## CALIFORNIA COASTAL COMMISSION

**STAFF REPORT:**

**SUBSTANTIAL ISSUE DETERMINATION  
AND DE NOVO REVIEW**

APPEAL NO.: A-3-SLO-99-019

# SECTION A-A'

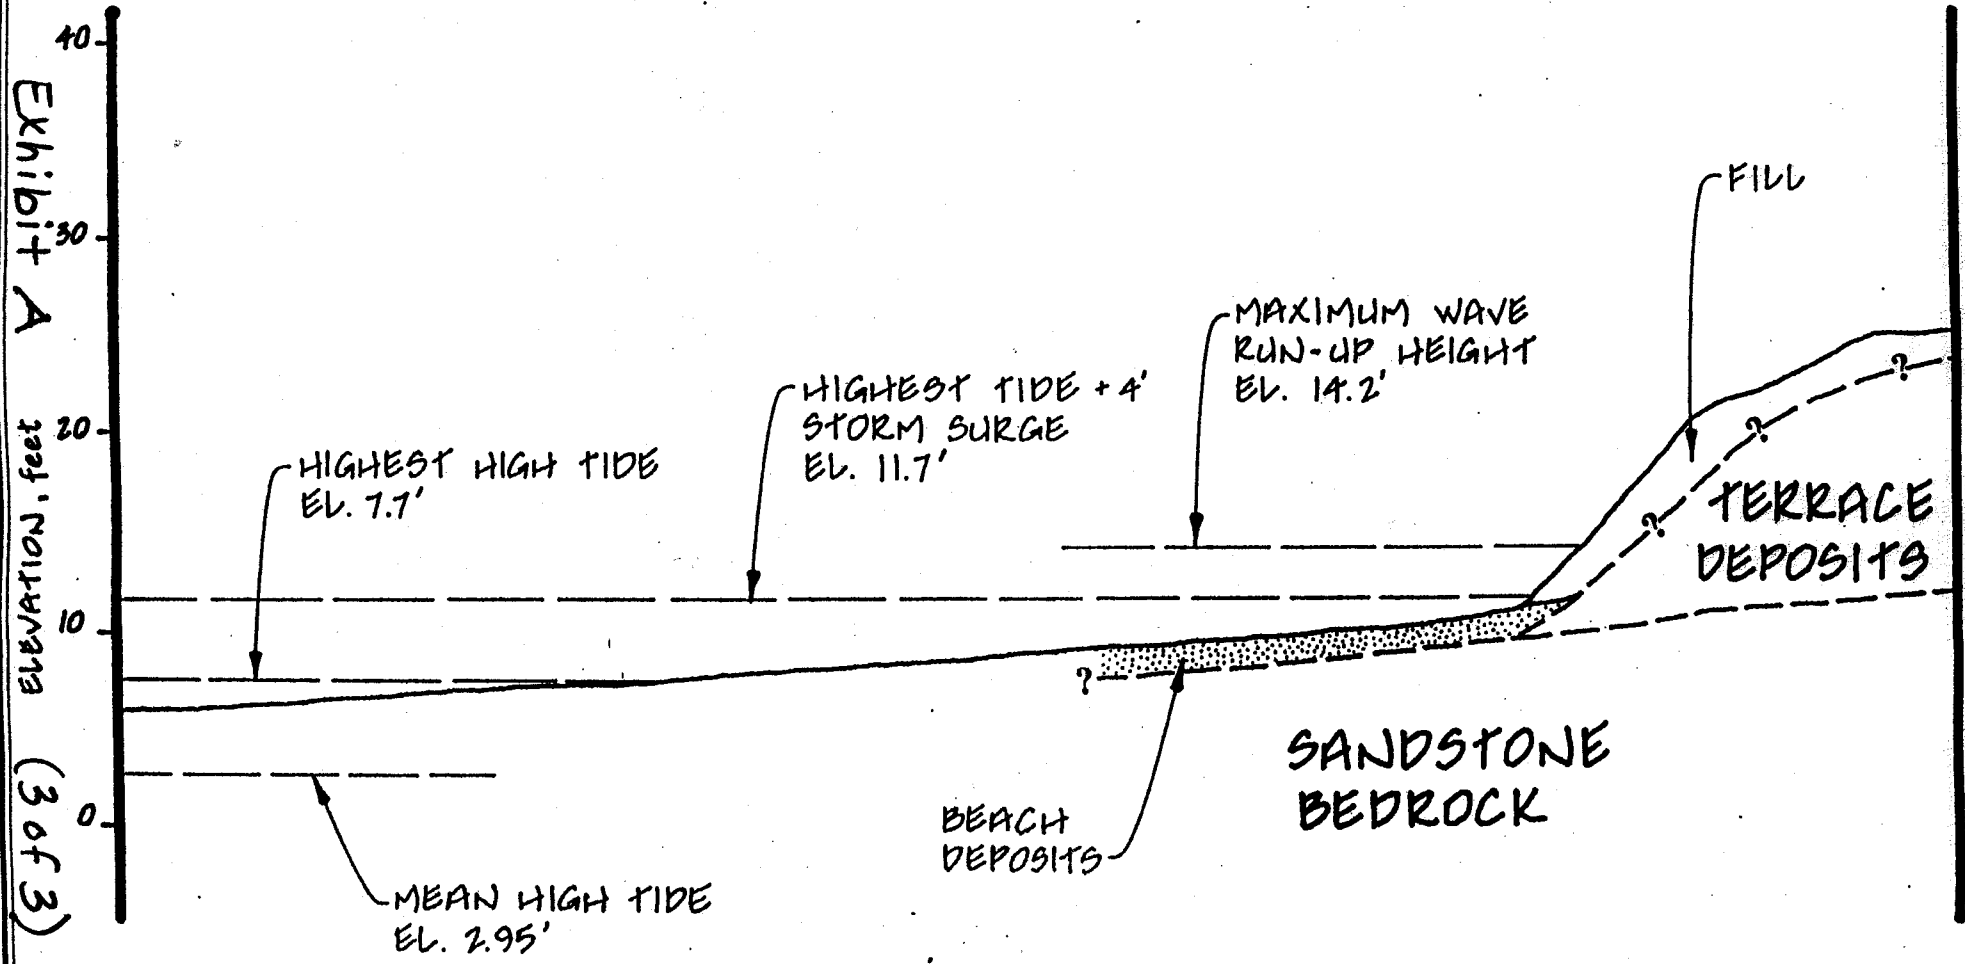
*The proposed structure should not affect the southerly transportation of the shoreline sand. This is due to the revetment being located about 8 feet above mean high tide (see Cross Section A-A') [attached as Exhibit A - Site Map]. The longshore sand transportation occurs at less than 50 feet out from the bluff, as indicated by the minimal deposit of sand on the beach at the site (less than 2 feet).*

Although the above assertion addresses the longshore transport of sand, insufficient evidence has been provided to conclude that the proposed revetment would not 1) change the beach profile and reduce the area located seaward of the ordinary high water mark; 2) interfere with bluff erosion that supplies sand to nourish the beach; and 3) cause greater erosion on adjacent beaches. Based on the lack of this critical information for sand supply analysis, the appeals raise a substantial issue regarding conformity with CZLUO Section 23.05.090 c(2) and (4).

Project  
 Alternative  
 (seawall)

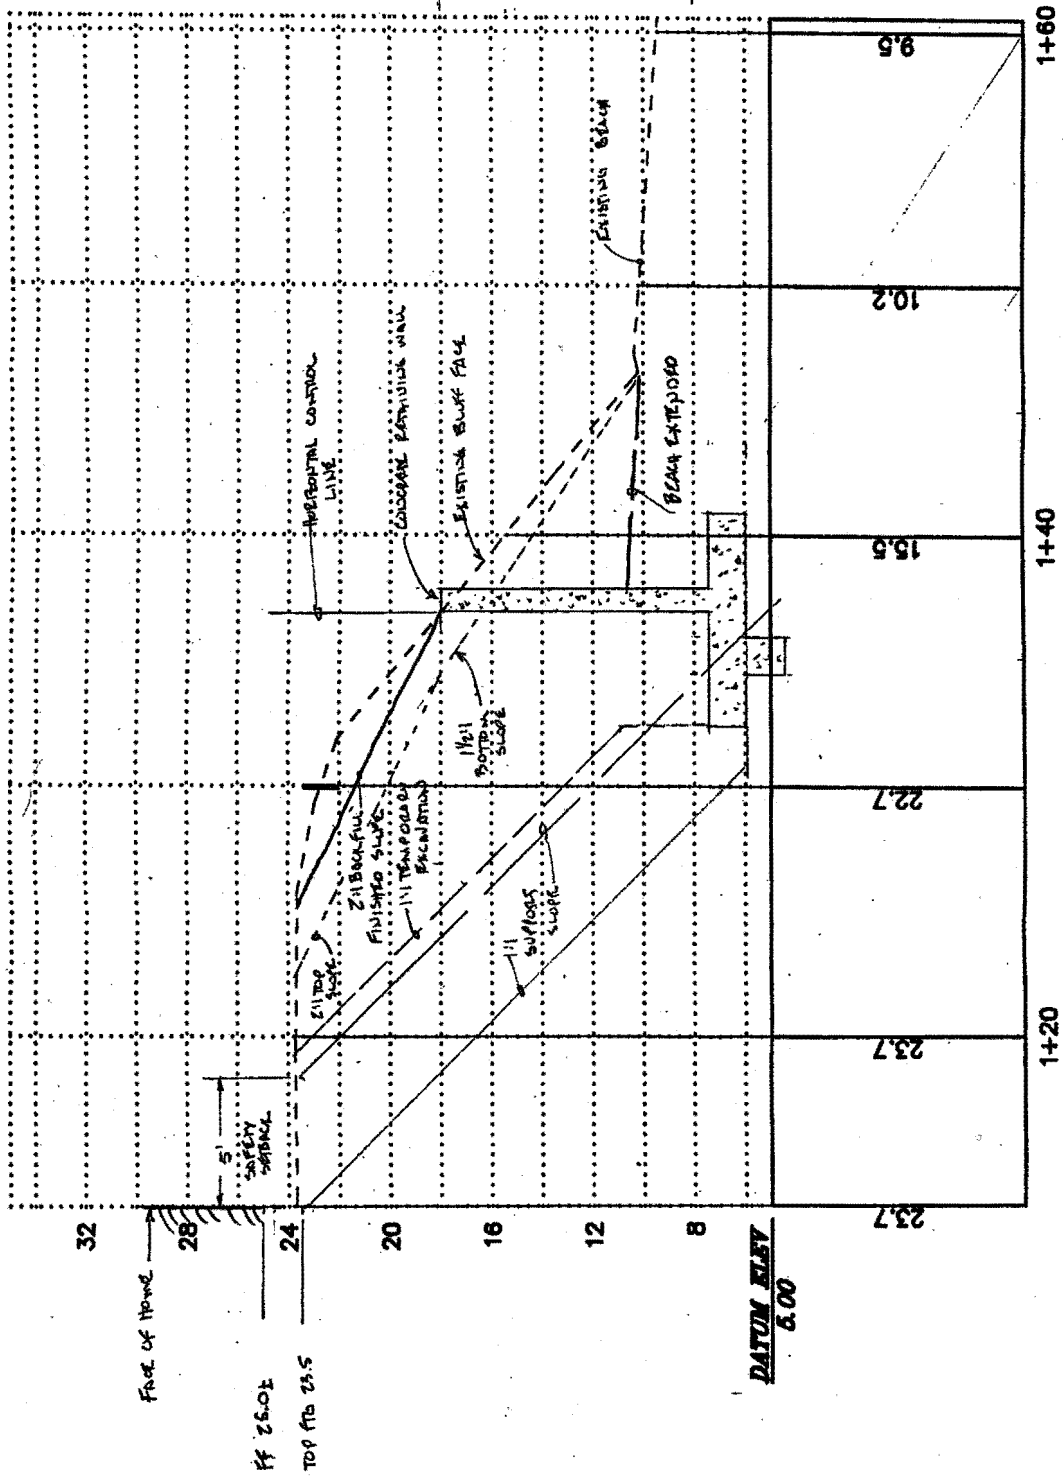
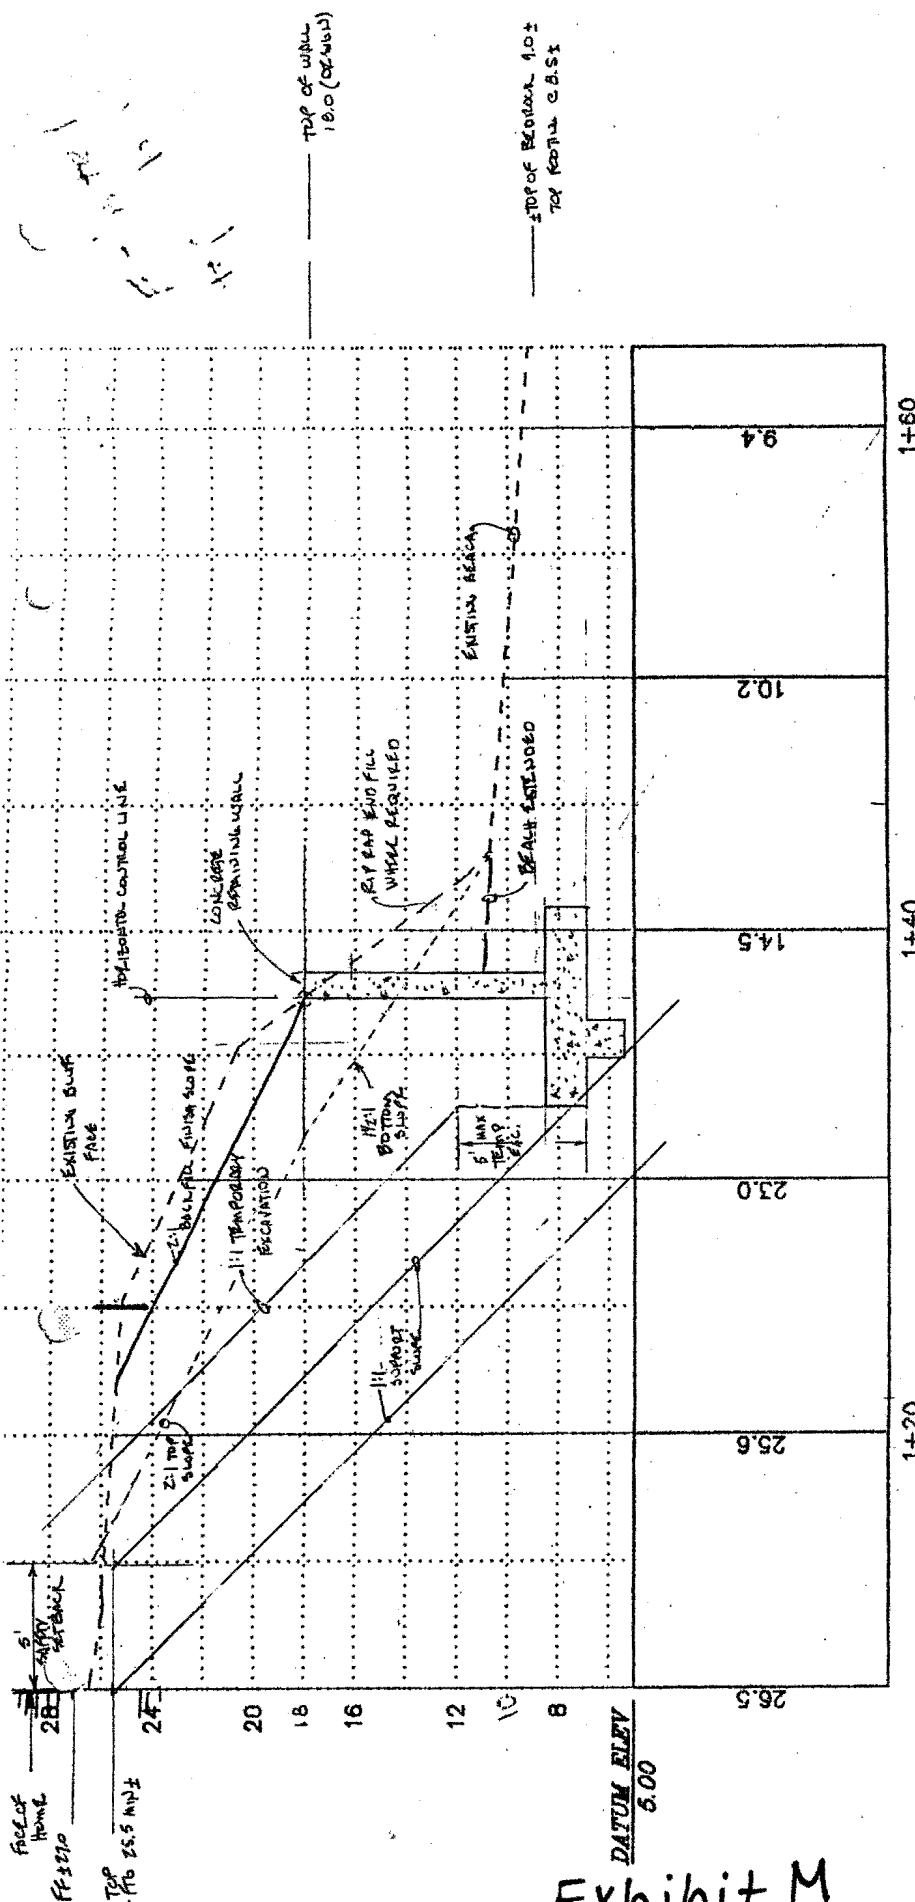
In the short term, the vertical seawall proposal, involving cutting and filling of the existing bluff, may have a lesser impact on public access than the proposed revetment, as it would not necessitate covering a significant portion of the sandy beach (please see Exhibit M). However, in the long-run, as is true of most shoreline structures, the seawall would eventually cause the dry beach to disappear, as explained in more detail below, which leaves the seawall to protrude into the ocean, thereby inhibiting public access to and along the beach.

You have indicated that the Commission may consider/prefer the installation of a vertical (concrete) wall because it would not reduce the area of public access on the beach. Construction of a vertical wall which would not reduce the extent of existing public beach access requires that the wall be installed conceptually as shown on the attached cross section (Alignment) sketches. The sketches show a 1:1 slope line extending from the bottom of the condominium structure footings, representing the potential limit of the building bearing pressure zone. The limits of temporary construction for the installation of a vertical concrete retaining wall are shown on each alignment. Alignments A & B show the footing corner excavation at or intruding into the 5' safety setback pressure bearing zone. It should also be noted that two bluff face "slumps" have occurred along this bluff face at these locations as located and documented in the Earth Systems Consultants Geologic Bluff Study. The Alignment A sketch shows that temporary excavation for the installation of the conceptual wall catches existing grade at 6' from the face of the existing residences. The Alignment B section catches existing grade at 9' from the face of the existing structure. Delaying installation of a bluff protection structure will result in extreme construction cost inflation because more expensive structural construction methods may need to be employed the closer the erosion gets to the structures.

**Response:** It is proposed that a concrete retaining wall be installed to eliminate any net "take " of public access, and provide additional beach area at the toe of the bluff.

ATTACHMENT 2

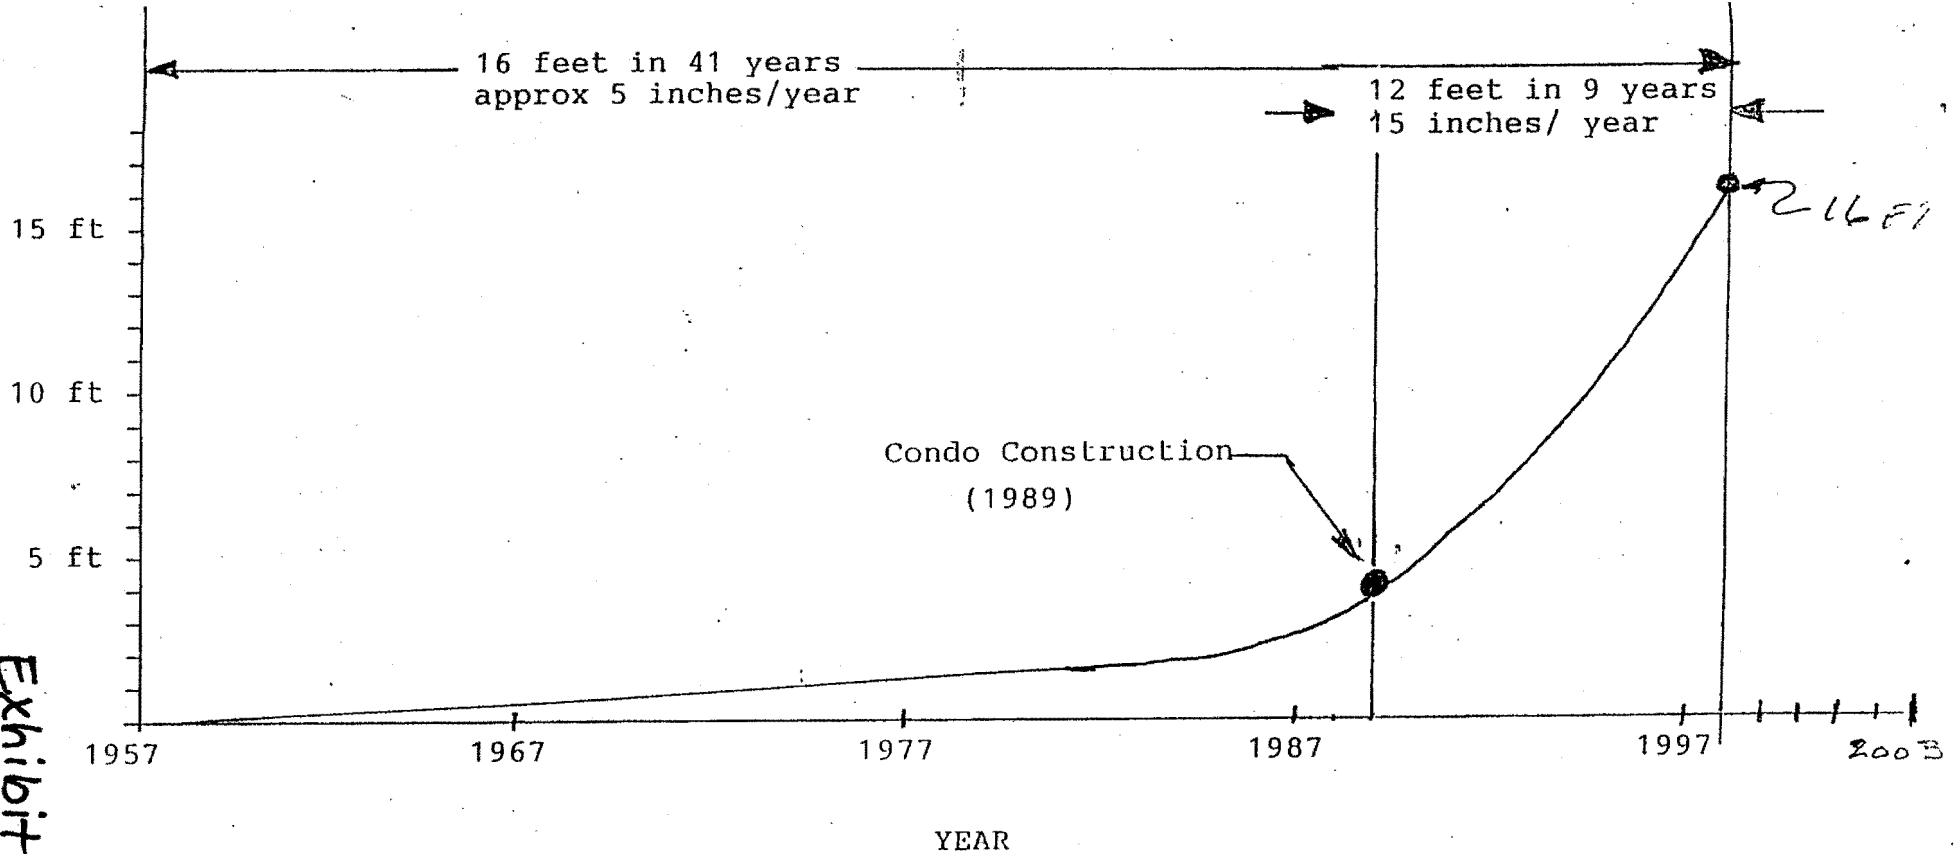
*We have determined, based on a record development plan and recent field measurements, that there has been approximately 13 feet of bluff erosion since 1989, a short term bluff retreat rate in excess of over one foot per year.*

ACCELERATED RATE OF BLUFF RETREAT BASED ON THE MARCH 19, 1998 GEOLOGIC BLUFF STUDY BY EARTH SYSTEMS AND THE KNOWN 25 FOOT SETBACK OF THE CONDOMINIUM AT 9229 BALBOA FROM THE BLUFF FACE WHEN THESE UNITS WERE CONSTRUCTED IN 1989.
